ADDENDUM NO. 1:

Date: February 20, 2017

Project: The EDGE Business Resource Center

Architect: Ward Scott Architecture, Inc.

Typical Pole

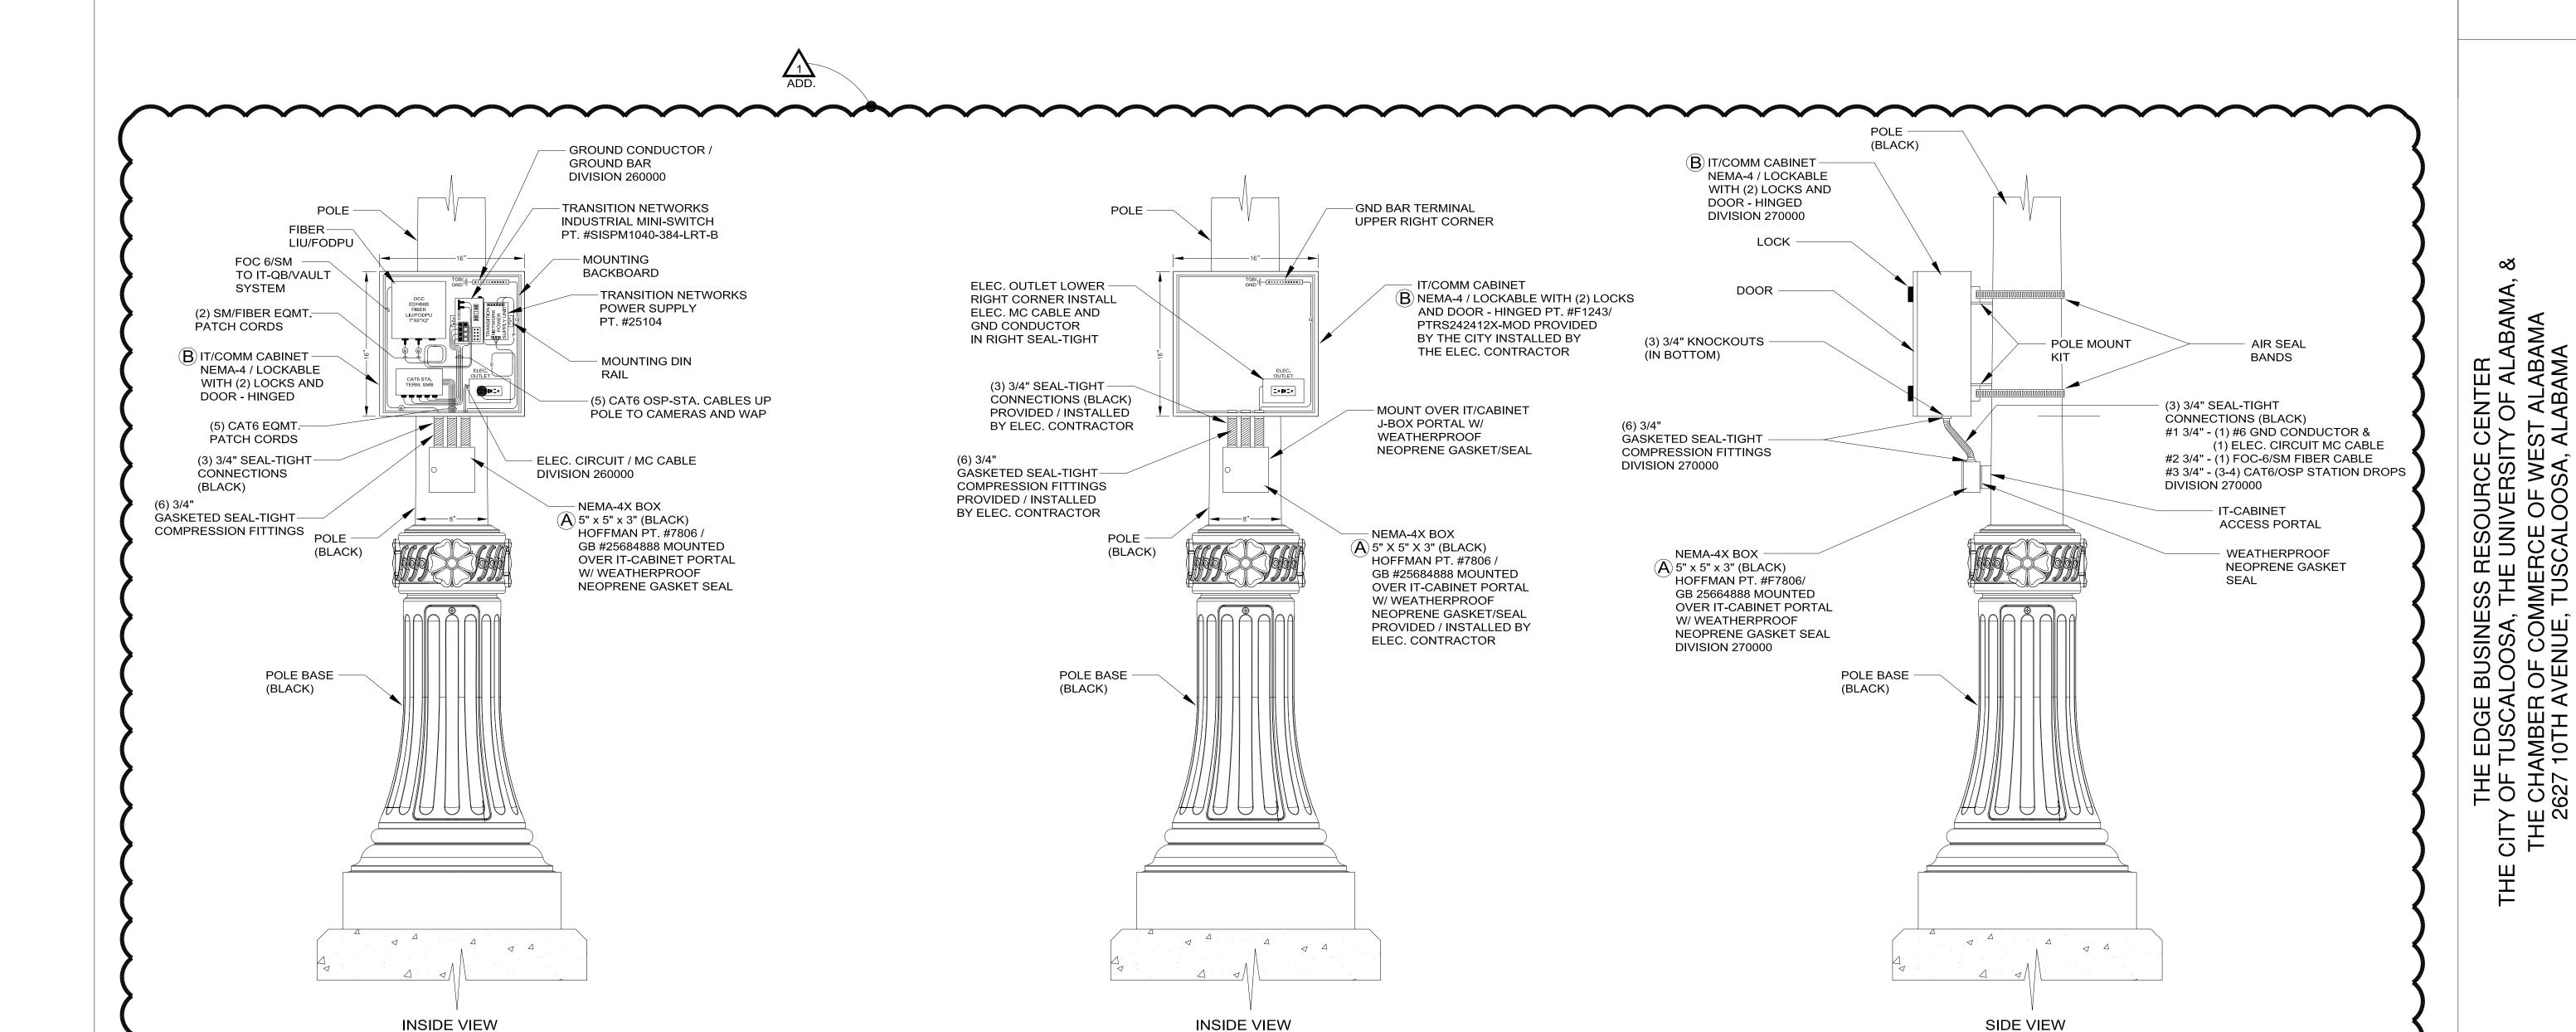
- 1. Re-issued drawing in its entirety. (Replace Drawing TD302)
- 2. No scope change, updated detail drawings. Noted clarifications to notes for the contractors.

Typical IT-Cabinet Detail Drawing

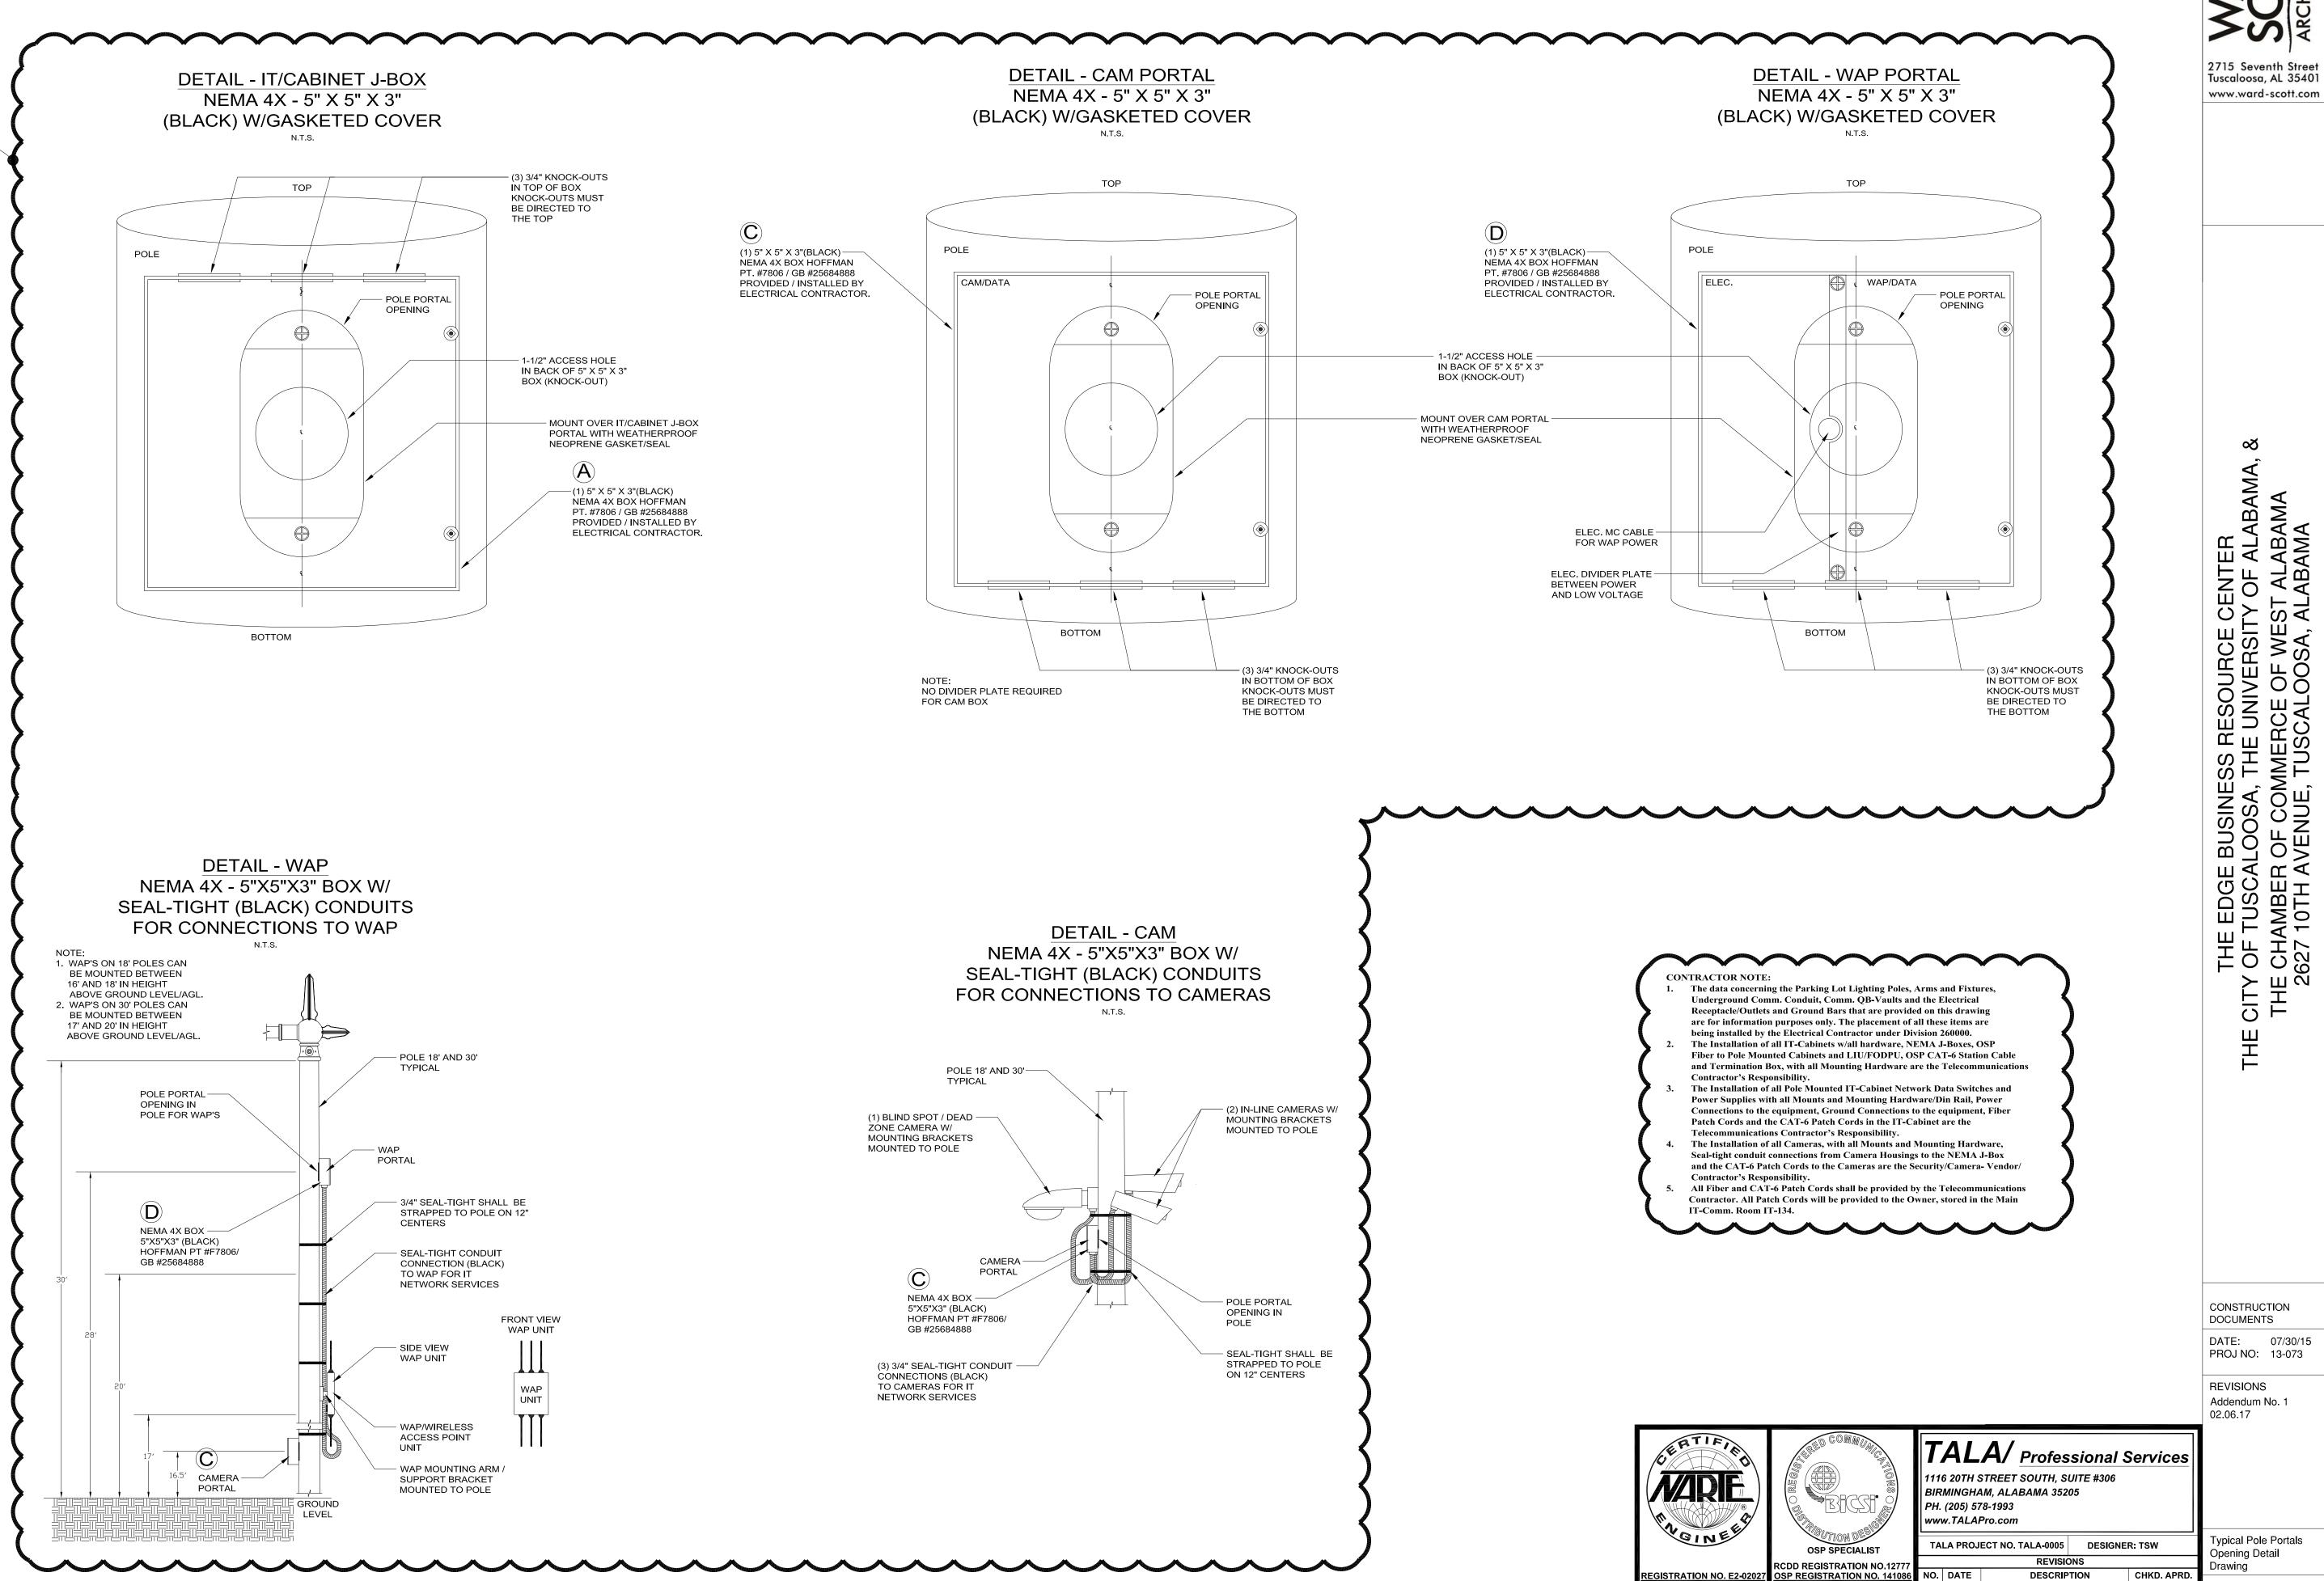
- 1. Re-issued drawing in its entirety. (Replace Drawing TD303)
- 2. No scope change, updated detail drawings. Noted clarifications to notes for the contractors.
